2000-1 Addison Circle

1996 Huit-Zollars Correspondence

RE: Addison Circle Phase 1 Public Infrastructure
Transverse Sawed Dummy Joint Spacing

EXHIBIT "B-1"

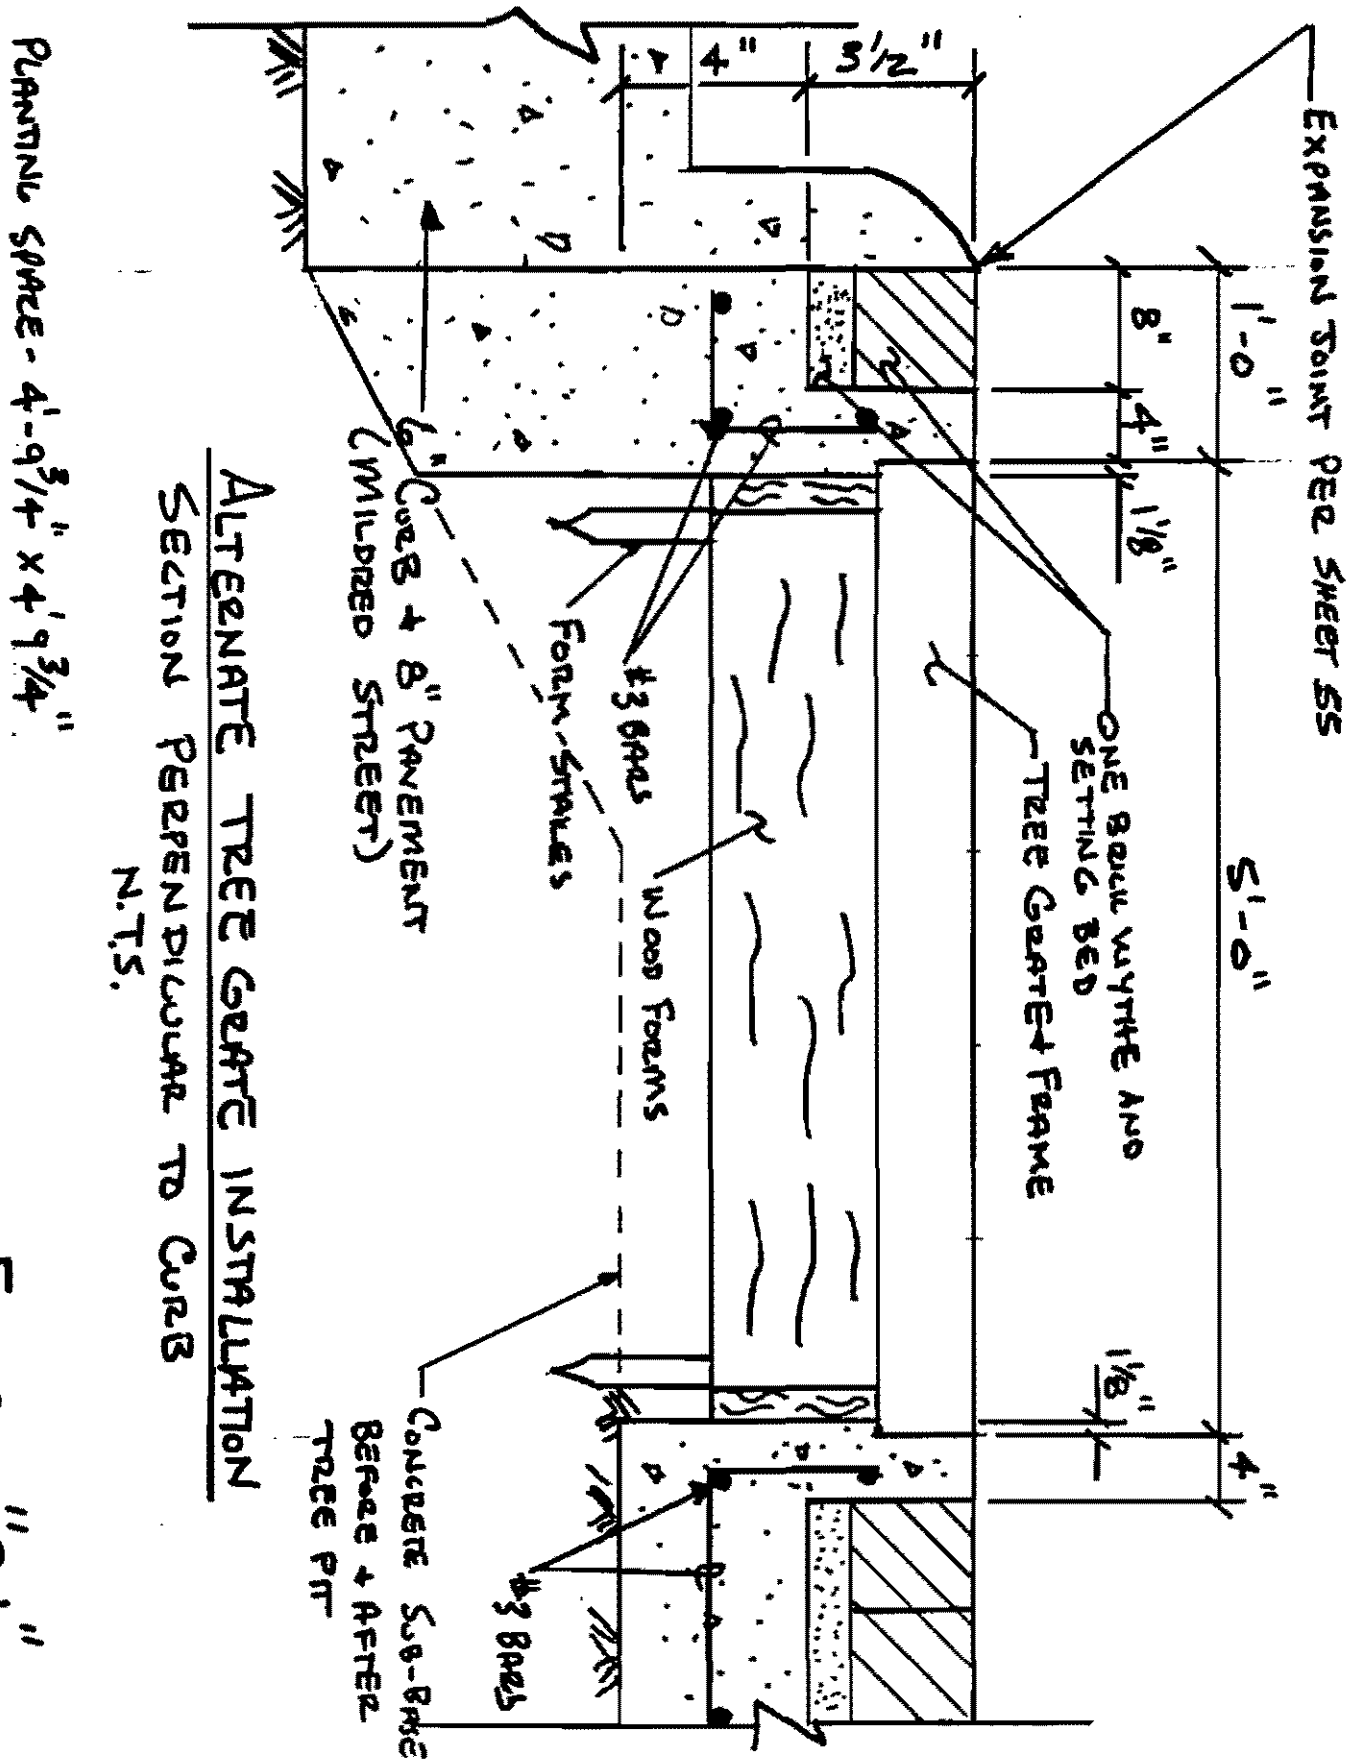
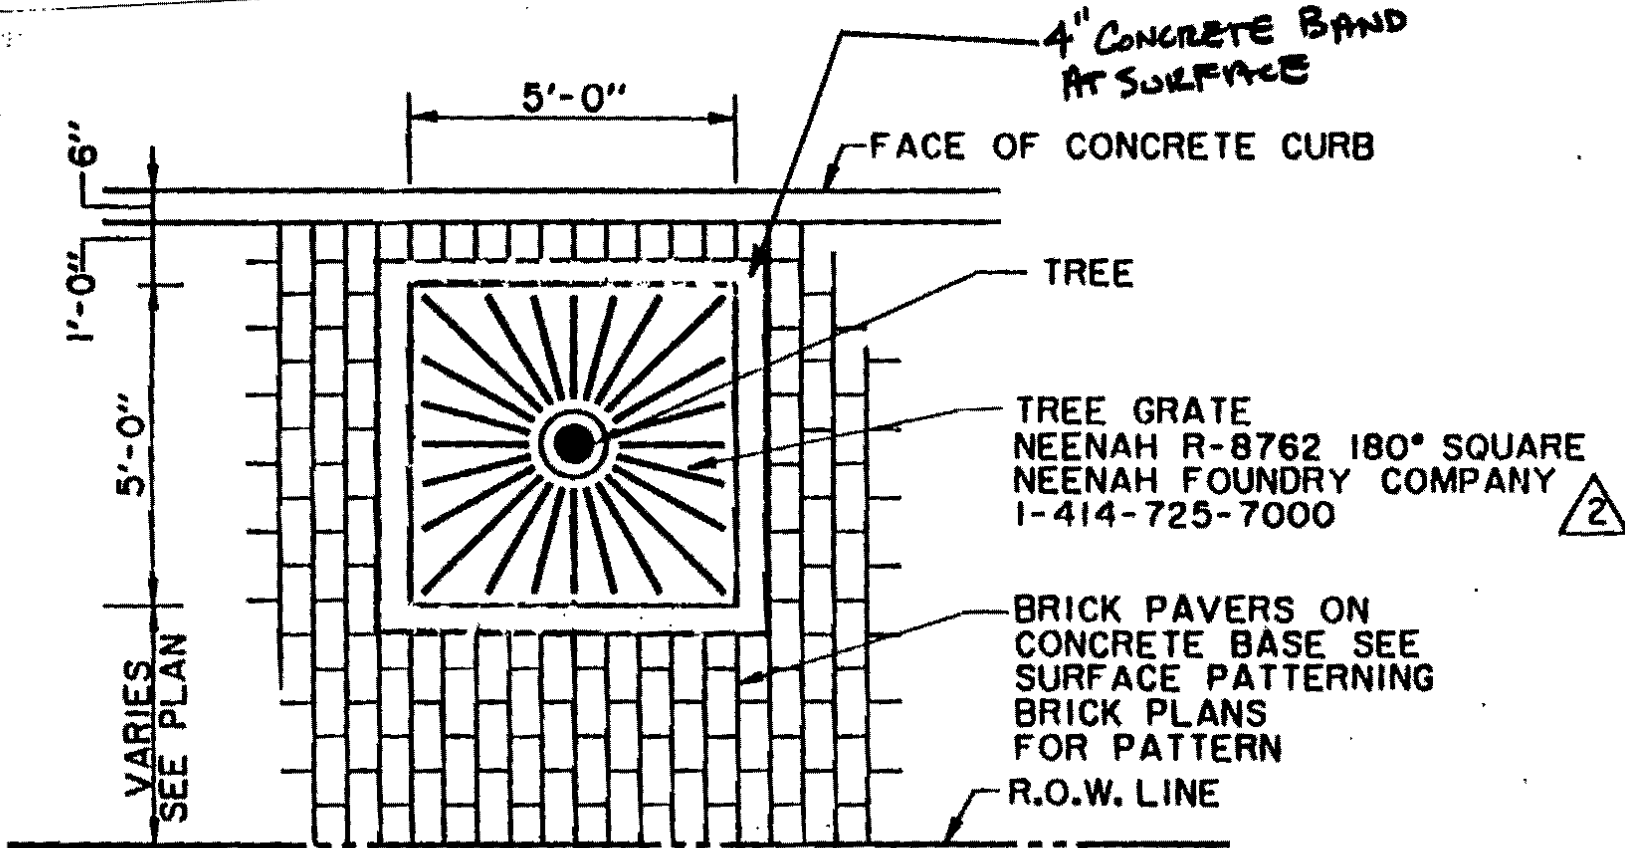
You have requested that a concrete band be poured to the surface allowing for added support which would be a similar installation procedure to that recommended by the manufacturer. We have illustrated your request in Exhibits "B-1" and "B-2". The installation would call for an approximate 4" concrete band around the grate at the surface. Although this installation is acceptable from an engineering perspective, it must still be approved by the landscape architect and Columbus Realty Trust.

EXHIBIT "D-2"

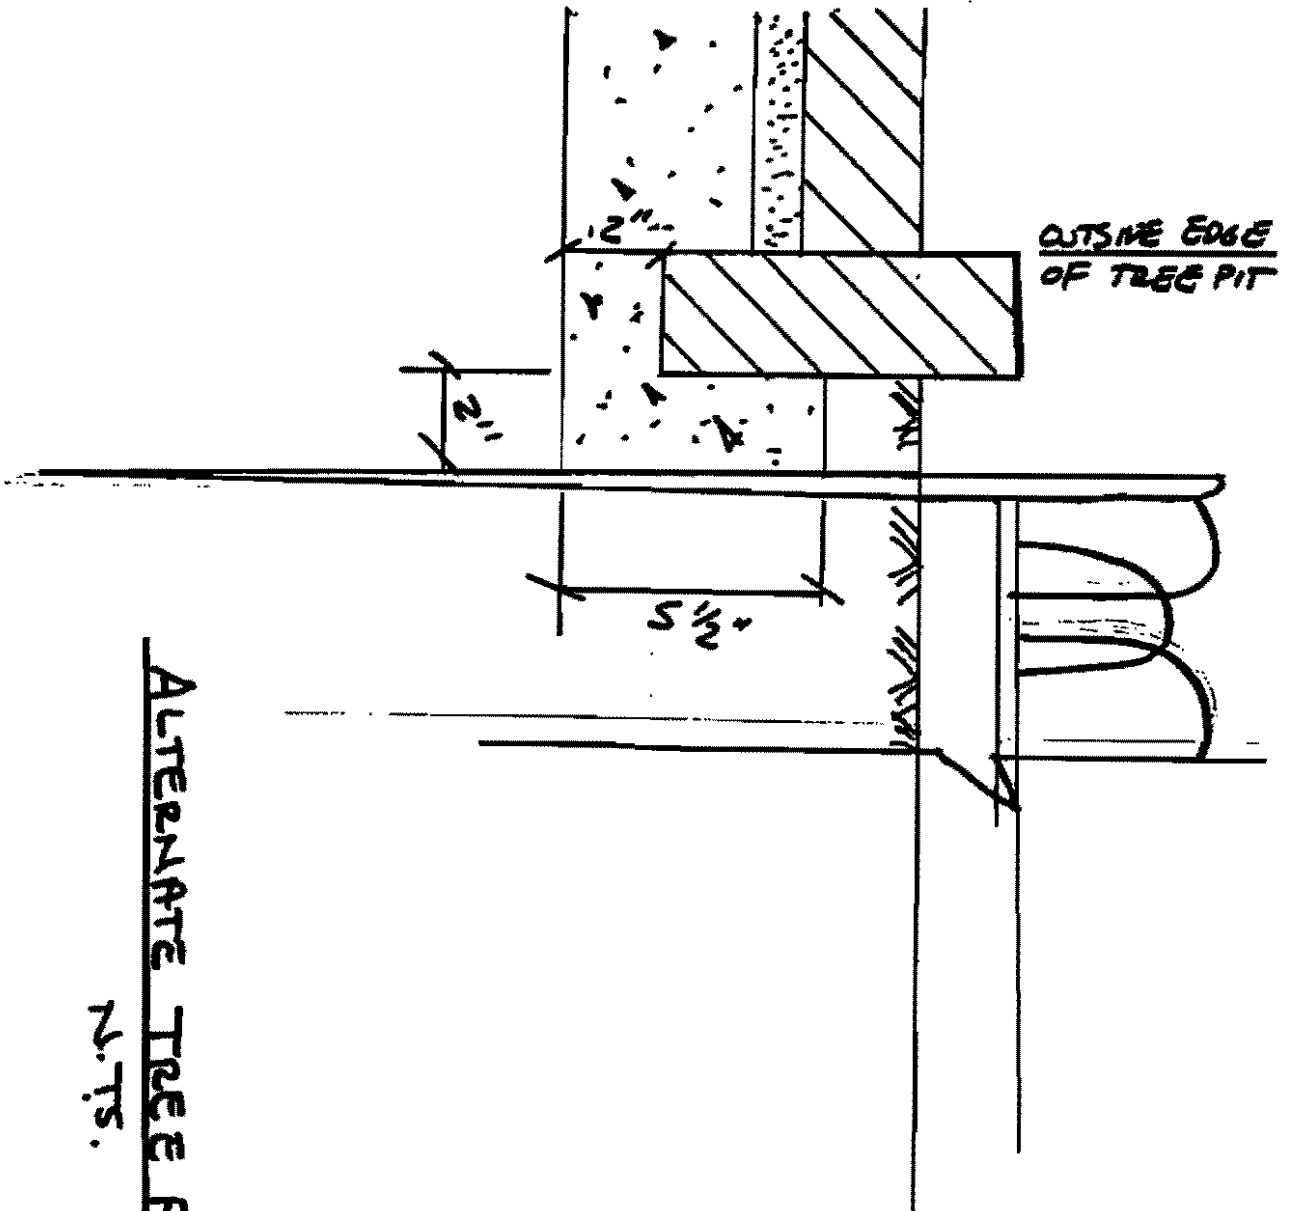
request in Exhibit "D-2". This design is similar to that for the soldier course at the back edge of sidewalk sections of Morris Avenue and McKamy Avenue as shown on sheet 55 of 137. However, this design reduces the planting area from 4'- 5 1/2" to 4'- 1 1/2" for a 200 gallon tree.
